**Franklin County
Rehab Center, LLC**

RE: Docket No. GMCB-007-23con, Transfer of 30 Skilled Nursing Facility Beds from The Villa Rehab Center to Franklin County Rehab, LLC and the Construction of an Addition to Accommodate 30 Beds and Associated Space.

Thank you for your letter dated June 6, 2023, with questions about my request for a waiver under Section 5 of Act 4, An Act Relating to Extending the COVID-19 Health Care Regulatory Flexibility. Please see my responses below.

First Floor Plan - NTS
Patient Floor/Level of Exit Discharge

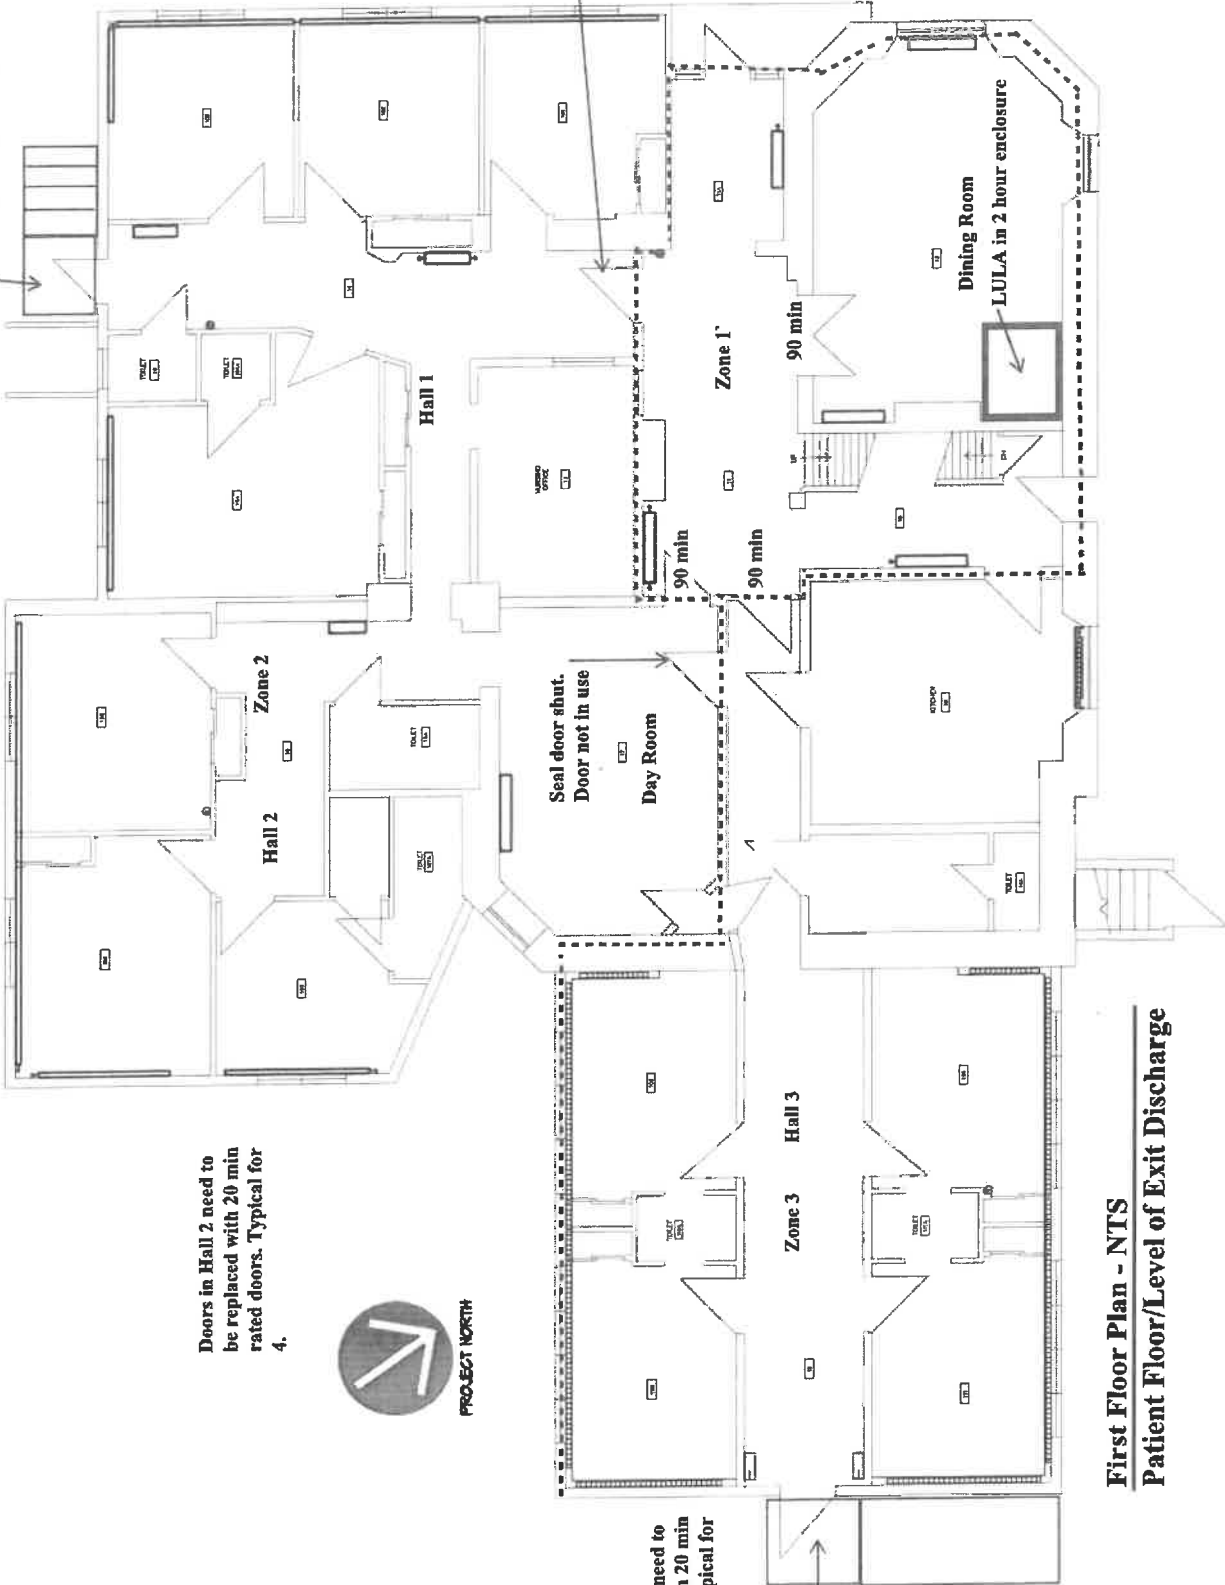
Egress to metal stairs to be replaced.

Doors in Hall 2 need to be replaced with 20 min rated doors. Typical for 4.

Replace with 90 minute door

First Floor Plan - NTS
Patient Floor/Level of Exit Discharge

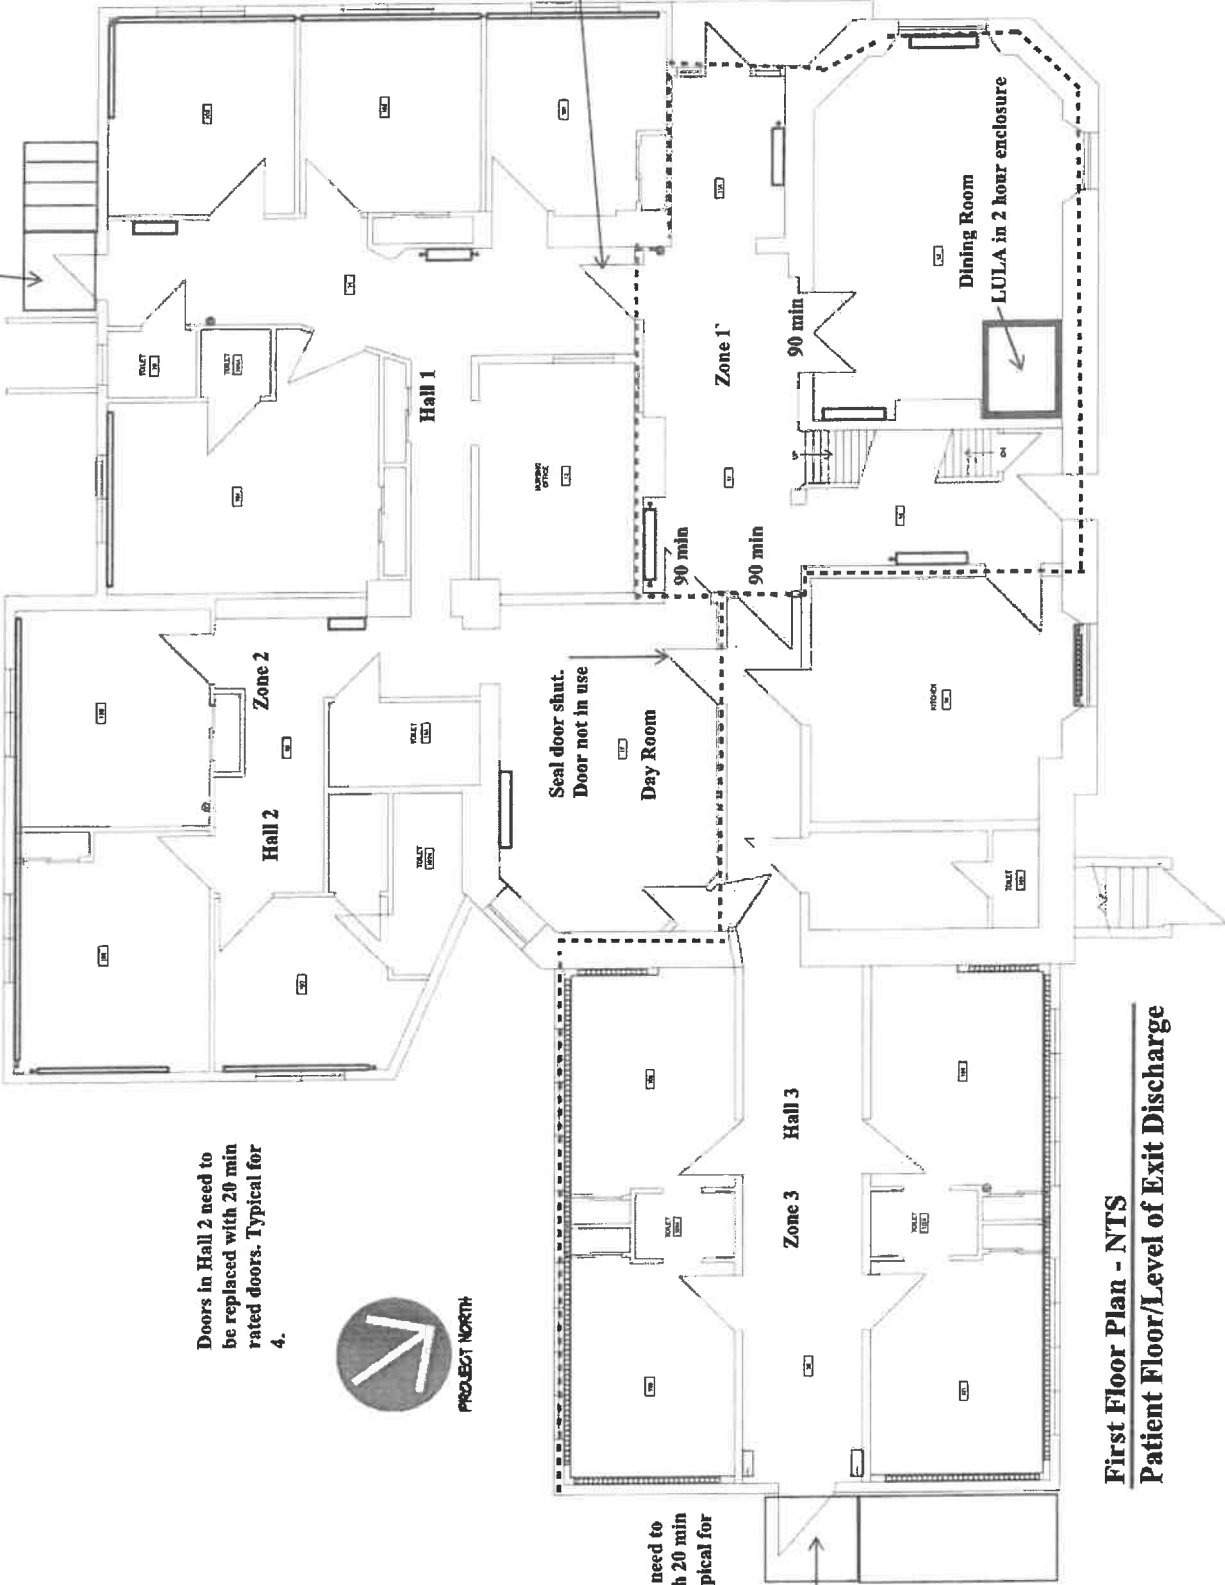
Egress to metal stairs to be replaced.

Doors in Hall 2 need to be replaced with 20 min rated doors. Typical for 4.

Replace with 90 minute door

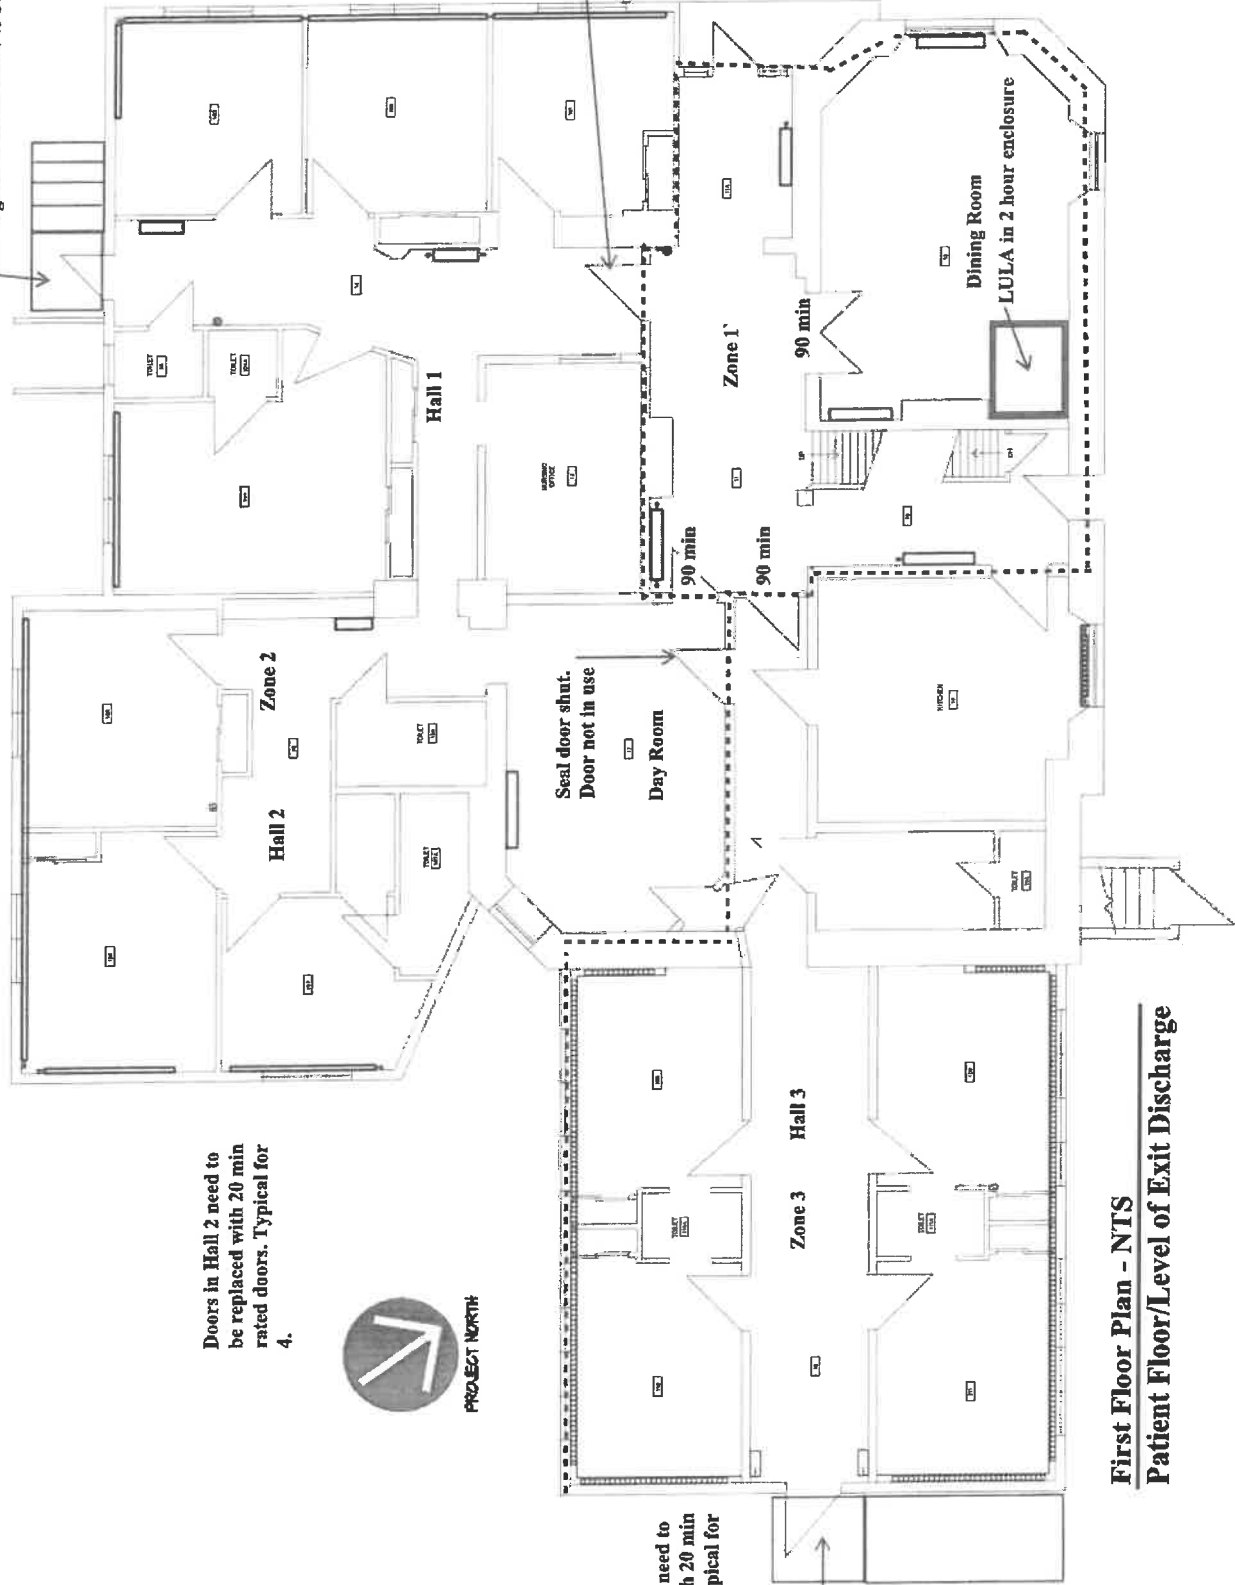
Egress to metal stairs to be replaced.

Doors in Hall 2 need to be replaced with 20 min rated doors. Typical for 4.
